1865 Woodmoor Dr - Clubhouse

1865 Woodmoor Dr
Monument, CO
AS BUILT

Floor Plan - Clubhouse
Scale
3/16" = 1'-0"

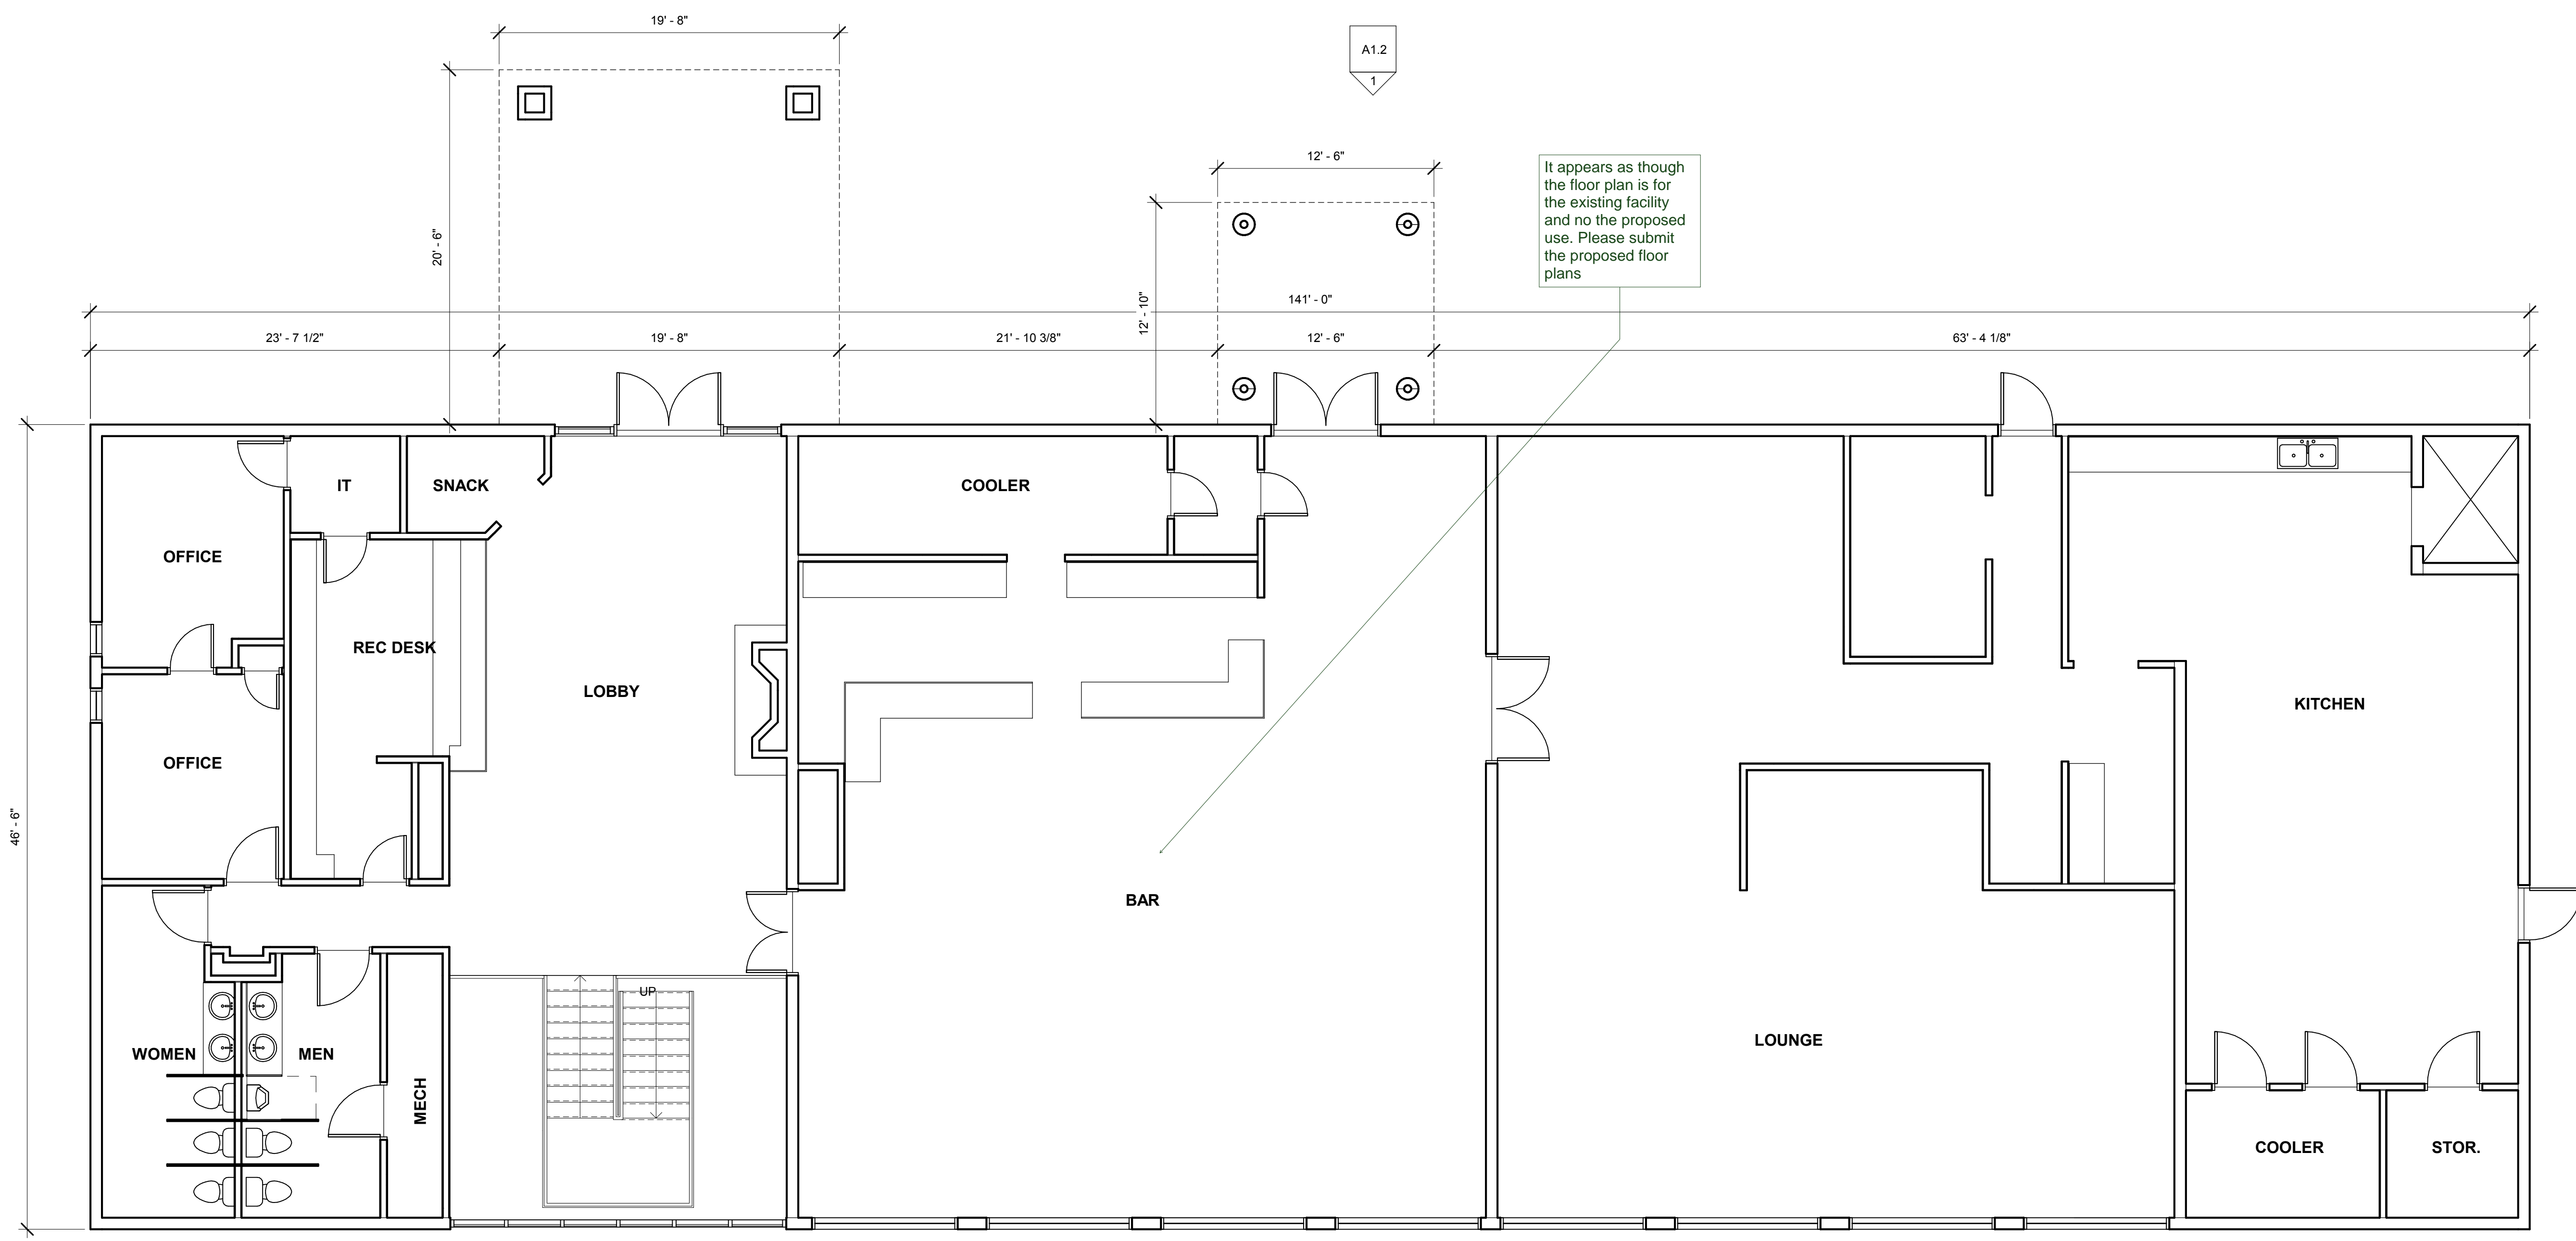
It appears as though the floor plan is for the existing facility and no the proposed use. Please submit the proposed floor plans
